Office Action Summary

10/715,040

SU ET AL.

DETAILED ACTION

FIG. 3

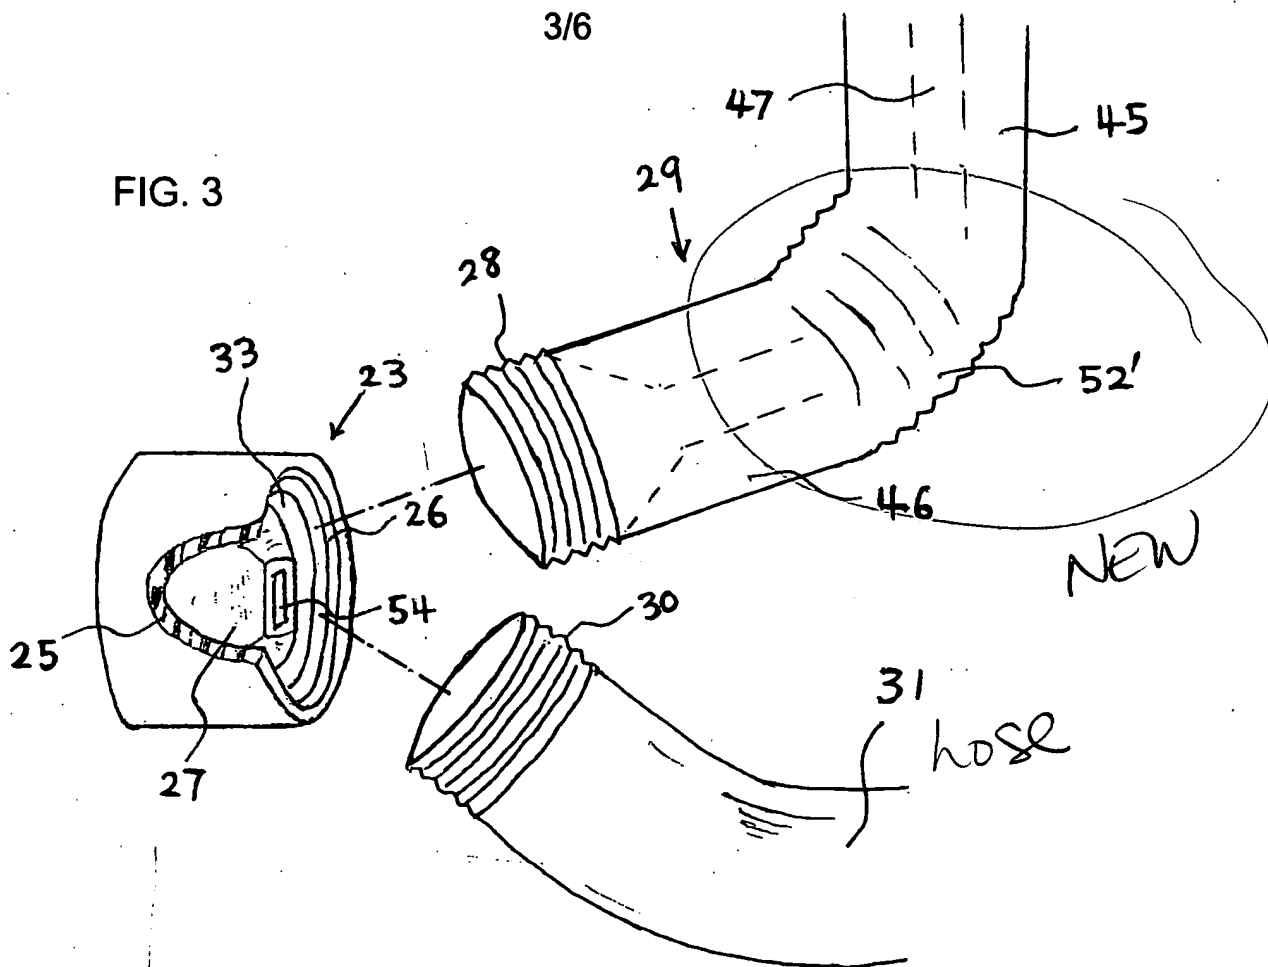
The drawings are objected to because Applicant has shown new matter in figures 3-4 with respect to element 52'.

shall introduce new matter into the disclosure of the invention. The added material which is not supported by the original disclosure is as follows: The element 52' in figures 3-4. Any reference to reference numeral 52' in the drawings or in the disclosure should be removed. The specification which includes the reference of Gauthier 3921635. This information was not as originally filed. Applicant should be arguing this reference that the Examiner presented in the office action under the heading arguments and should not be amending the specification to include this reference or any new information which pertains to this reference into his/her disclosure. (See page 4 paragraph 2 of applicant's sub specification.)

not ok
8/15/07

Applicant is required to cancel the new matter in the reply to this Office Action. Applicant is requested to submit a marked up and clean copy of a substitute specification.

FIG. 4

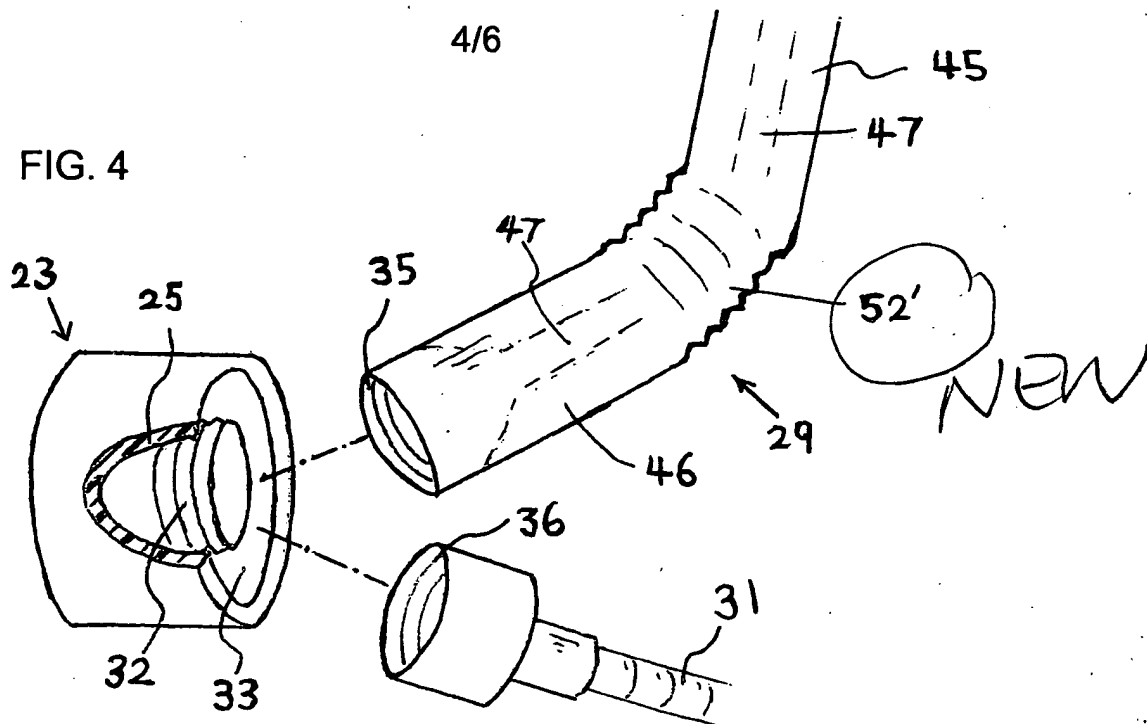
Not ok
1/5/17
